VALUE ENGINEERING STUDY

I-20 AT SAVANNAH RIVER Richmond County, Georgia

Project # IM000-0020-02(117) PI No. 210327-

05 May 2011

PROPOSAL NUMBER:	B-3.0
PAGE NUMBER:	3 of 4

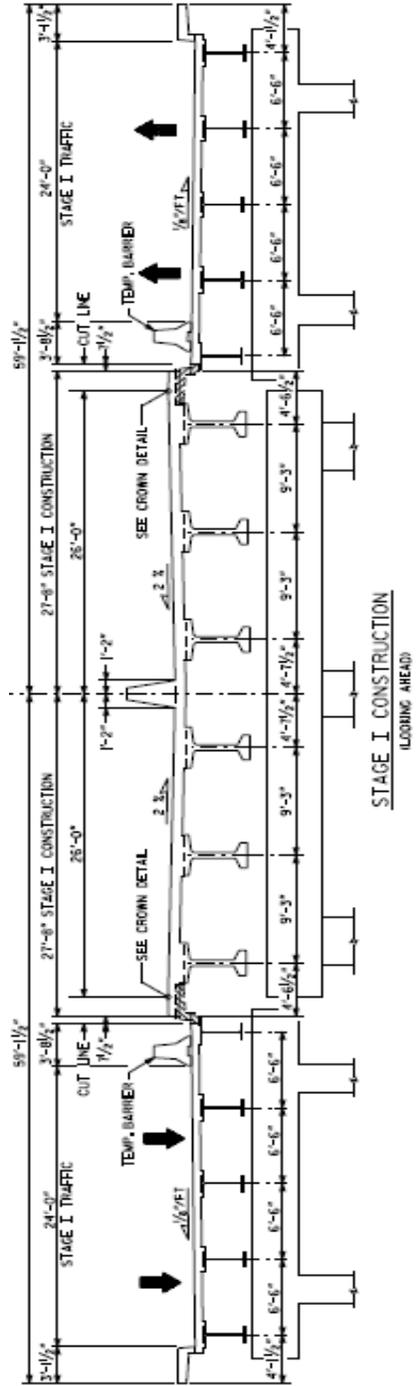
PROPOSAL DESCRIPTION: FOR BRIDGE CONSTRUCTION, BUILD 4 TRAVEL LANES (2 IN EACH DIRECTION) TO THE NORTH WITH STAGED CONSTRUCTION TO ELIMINATE CONSTRUCTION IN THE MEDIAN.

ORIGINAL DESIGN: Bridge replacements propose staged construction widening in the median to accomplish construction in two stages. Stage One will build center of new bridges in between 56-foot existing medians, while maintaining traffic on existing bridges. Stage Two will move traffic to center of new bridges and demolish existing bridges and widen accordingly to each side and shift traffic again to final location.

PROPOSED CHANGE: Recommend replacing bridges with staged construction by building first half to centerline of the proposed bridges (2-travel lanes in each direction) to the north in Stage One. Stage Two would demolish the existing bridges, widen the new bridges and shift traffic to final location.

JUSTIFICATION: Proposed change would reduce the number of traffic shifts by one and simplify construction staging. Construction of the bridges outside of the existing structures would be easier than constructing between the 2 existing bridges.

Proposed Change: build initial structure to North (outside existing bridges) for 4 lanes of traffic, shift traffic to new bridge, demolish existing bridges and widen new structure.

PROPOSAL NUMBER: R-1.0

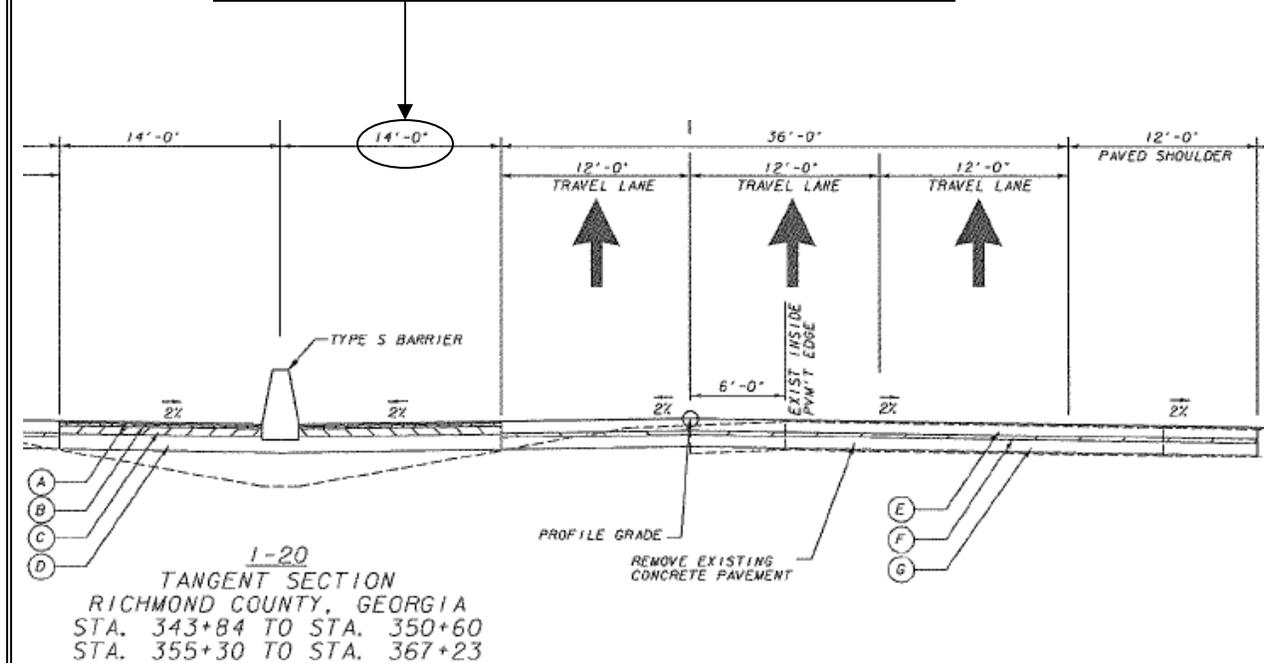
PROPOSED CHANGE: Change the inside paved shoulder width to 12'-0" (13'-2" less 1'-2" for concrete barrier).

Proposed Change: Revise 14'0" inside dimension to 13'2", with 1'2" barrier half width results in 12'-0" inside shoulder pavement width.

PROPOSAL NUMBER: R-2.0

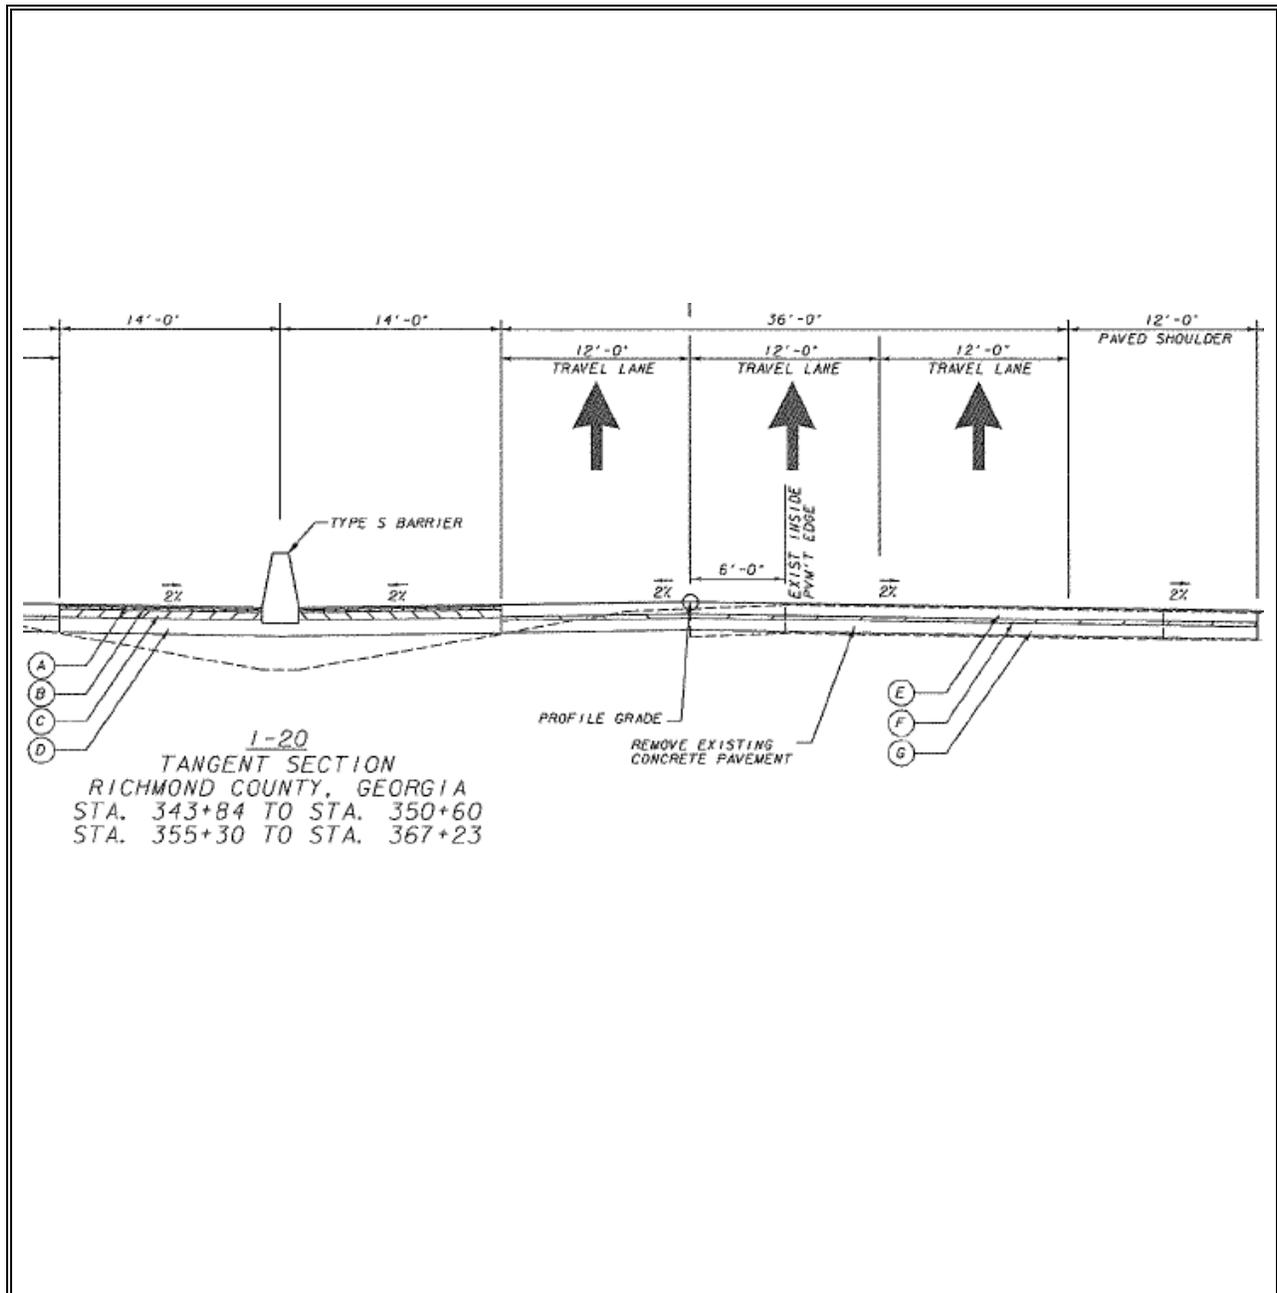
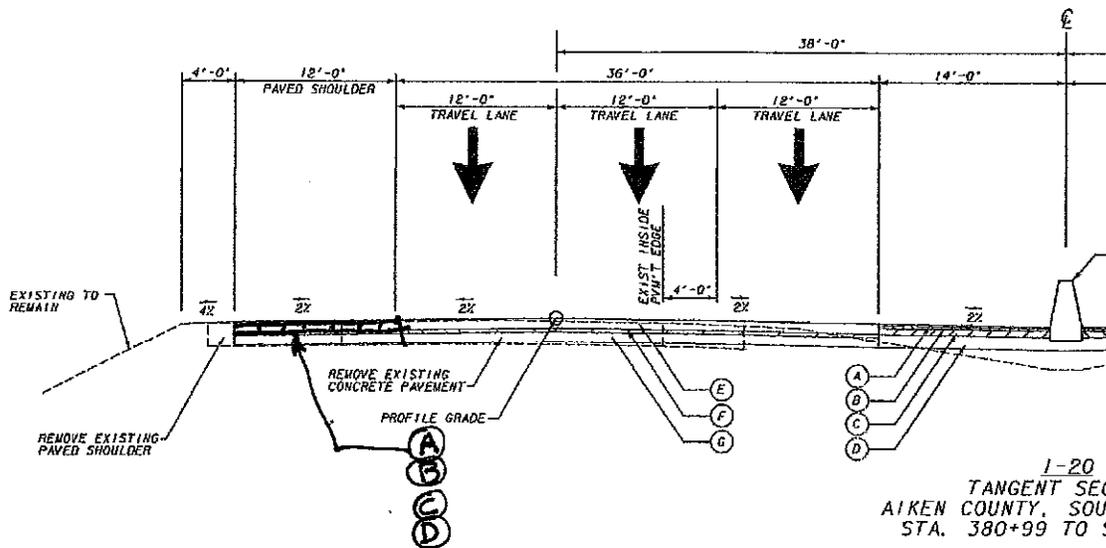
PROPOSED CHANGE: The proposed recommendation is to construct the outside paved shoulder with asphalt.

PROPOSAL NUMBER:	R-4.0
PAGE NUMBER:	3 of 3

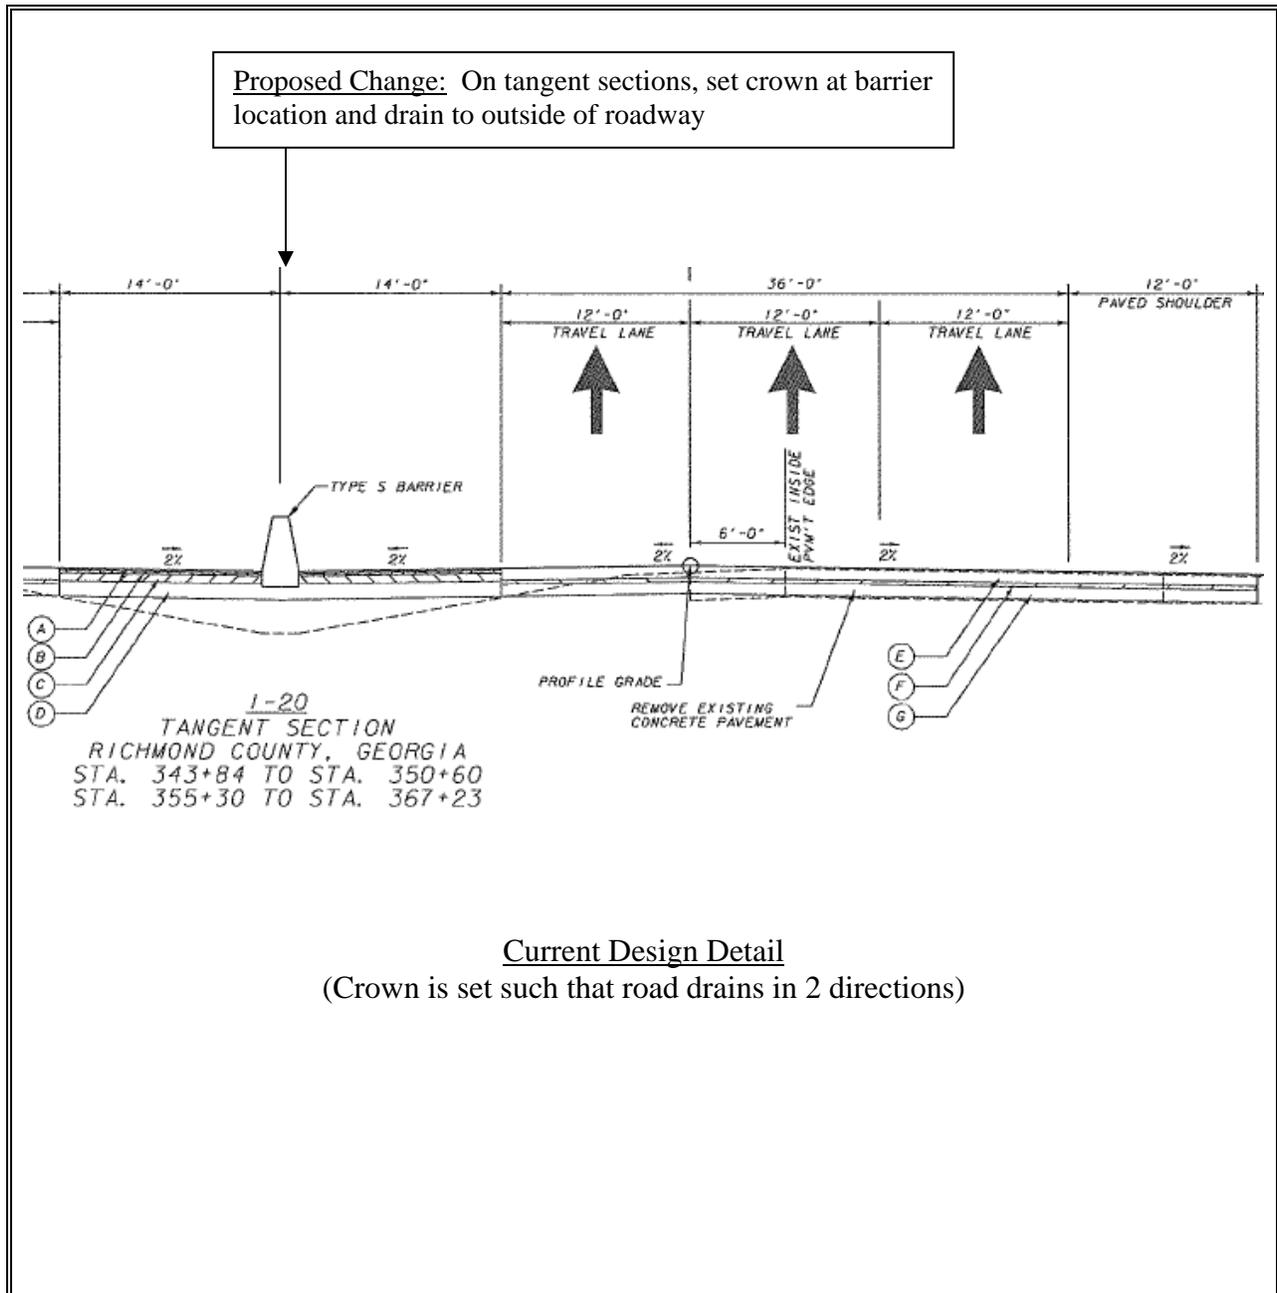
PROPOSAL DESCRIPTION: CHANGE CROSS SLOPE TO DRAIN ALL LANES TO OUTSIDE IN TANGENT SECTIONS IN LIEU OF INSIDE TRAVEL LANE WITH CROSS SLOPE DRAINING TO MEDIAN.

PROPOSED CHANGE: Slope all pavement in the tangent (straight) sections toward the outside and eliminate the drainage adjacent to the median barrier. Drainage on bridges (1970 LF) and horizontal curve (1290 LF) will not require change. Project (9316 LF) minus bridges and curve results in a 65% reduction in drainage items.
